**CERTIFICATE OF APPROPRIATENESS**

**Property:** 432 Arlington Street, Lot 21, Block 304, Houston Heights Neighborhood Subdivision. The property includes a 3,059 square foot, two-story wood frame single-family residence and a detached garage situated on a 6,600 square foot (50' x 132') interior lot.

**Proposal:** Alteration - Addition

- Enclose open air second-story porch into conditioned space
- Conditioned addition 22'x10' (220 sq. ft)

**Side Setbacks (Addition and New Construction)**

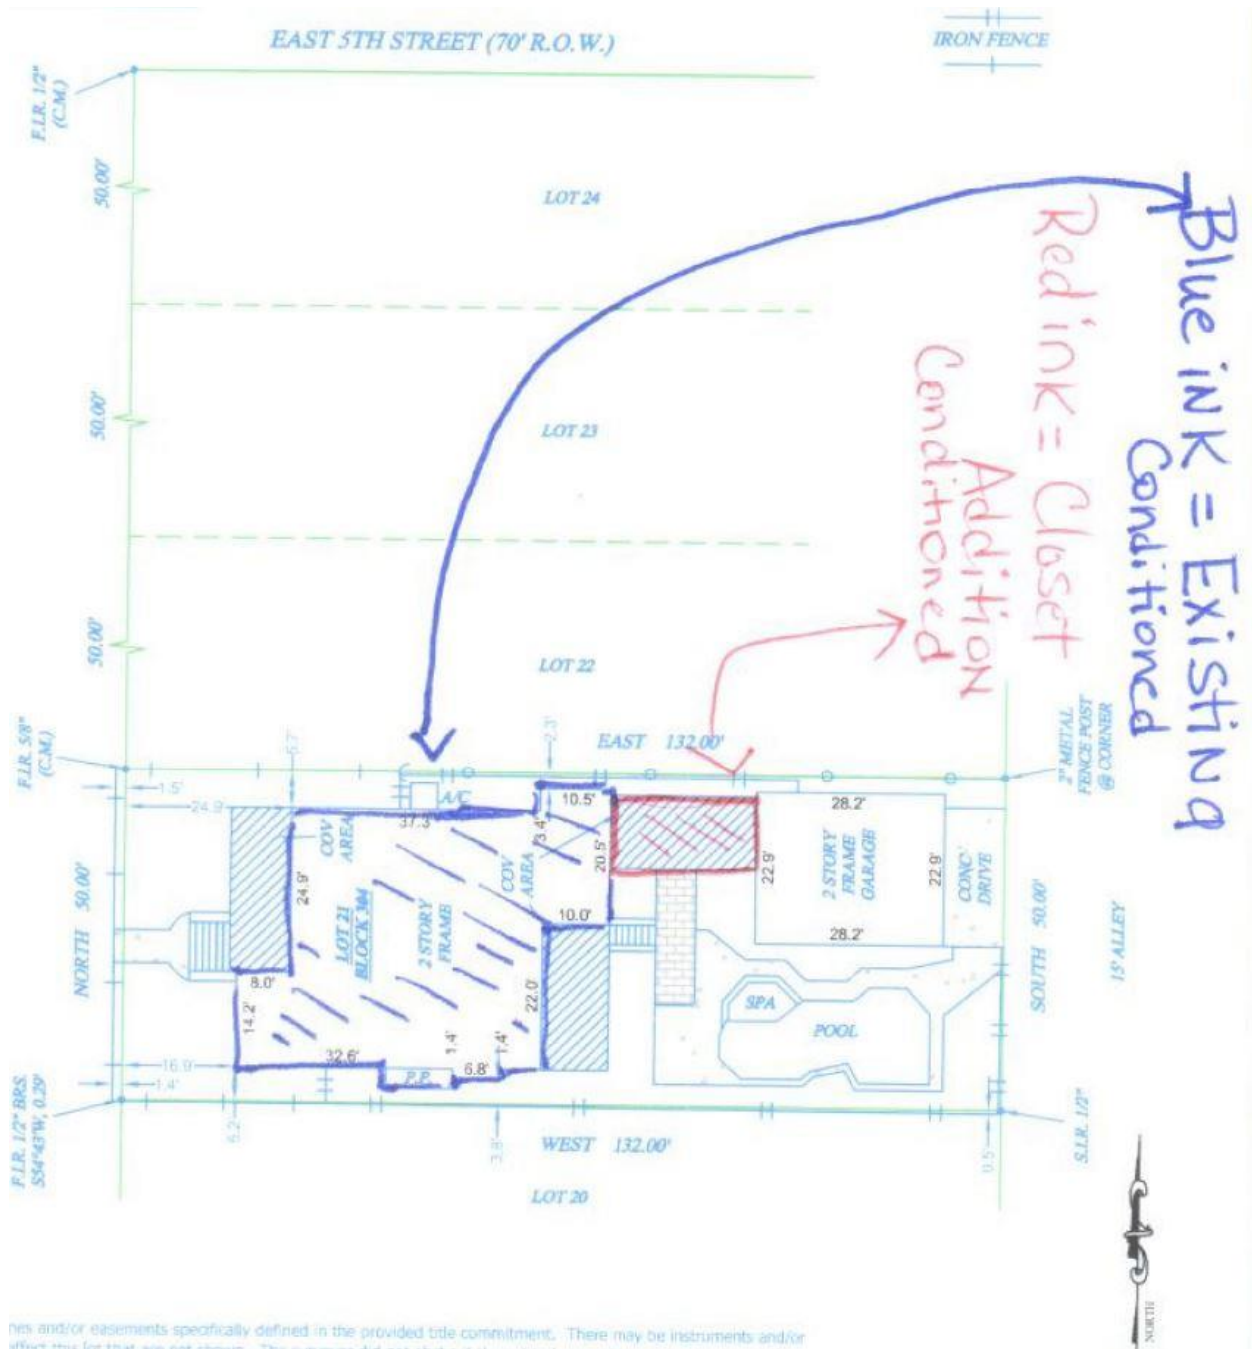
[ ] [X] [ ] (a) The distance from the property line to the front and side walls, porches, and exterior features of any proposed addition or alteration must be compatible with the distance from the property line of similar elements of existing contributing structures in the context area; and The present North side setback is approximately 2' 3" according to the site plan submitted for new construction in 2011. Houston Heights Design Guidelines requires a minimum 5' side setback (sec.5-11)

Proposed side setback (North): 2' 3"  
 Proposed side setback (2): N/A  
 Cumulative side setback: N/A

3D Renderings Provided By Applicant

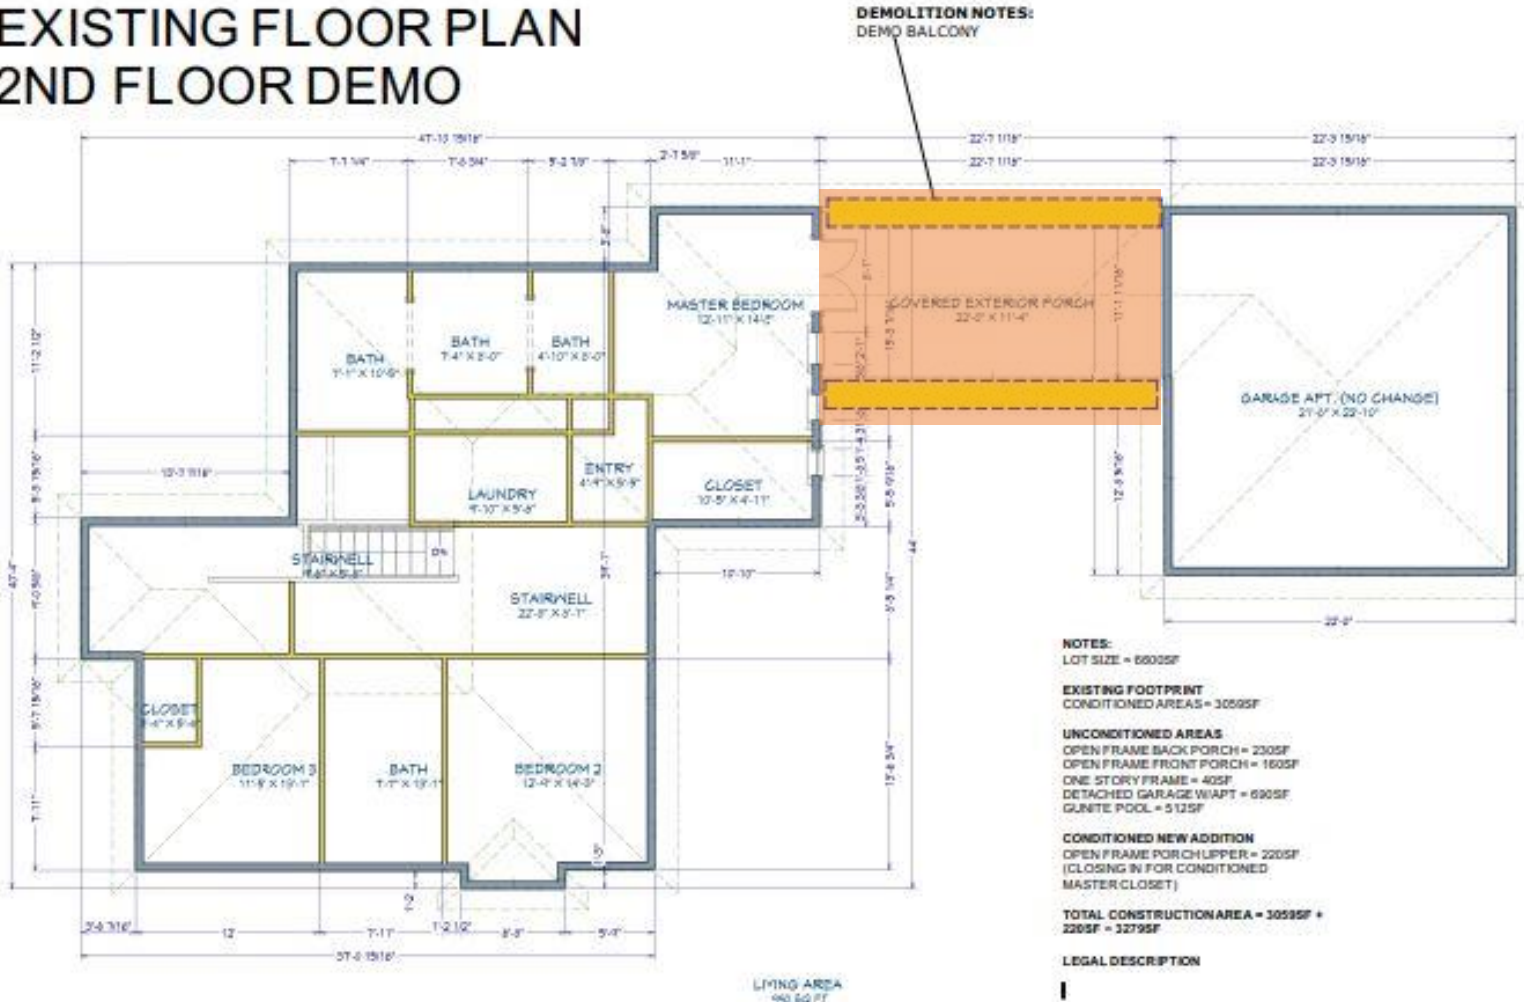
- 2. The proposed addition does not propose an inset as stated in the Houston Heights Design Guidelines (5-14).

Side Wall Length: 47' 2"  
 Inset Length: 0'  
 Inset on North side: 0'  
 Inset on South side: N/A
